# TECHNICAL REVIEWERS' RATING SUMMARY

R009-D

## G F Truss Plant Gasification System Redesign

Energy & Environmental Research Center  
Principal Investigator: Kerryanne M.B. Leroux  
Request for \$245,656; Total Project Costs \$491,313

Figure 1. Downdraft gasifier.

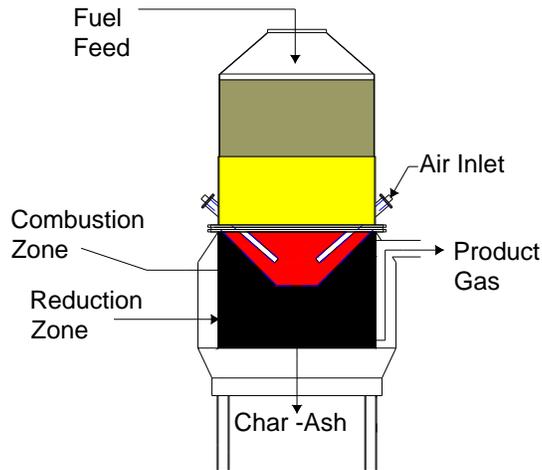
Details on what is to be done in the study are vague. For example what are some of the specific design modifications will be attempted with the GF Truss gasifier.

The PI does not seem to demonstrate a basic understanding of downdraft gasifier technology. Without this knowledge the likelihood of any meaningful contribution is remote.

Figure 1 shows the gasifier and general arrangement of the drying, pyrolysis, combustion, and char reduction zones in the gasifier. Downdraft gasifiers of this type (Imbert) produce low gas contaminants for two reasons. The bed is fixed (not fluidized), allowing for low carryover of particulates, and hydrocarbon vapors produced in the pyrolysis zone are drawn down through the high-temperature zone and cracked to lower hydrocarbons (less tar). The gasifier is under vacuum drawn by a high-pressure blower.

Figure 2 shows the commercially available Ankur gasifier currently installed at GF Truss and the demonstration EERC-designed gasifier installed at Northern Excellence. The straight-walled Ankur design has proved to cause bridging and feed flow issues, even with a wood chip feedstock. The conical shape of the EERC gasifier, slightly expanding as the feedstock moves

through each zone, has shown improved feed flow and elimination of bridging issues when using grass seed screenings as a feedstock. It is, therefore, hypothesized that installation of an EERC-designed gasifier at GF Truss will also eliminate feed flow and bridging issues using the wood chip feedstock. The first task of the proposed project is to test this hypothesis.
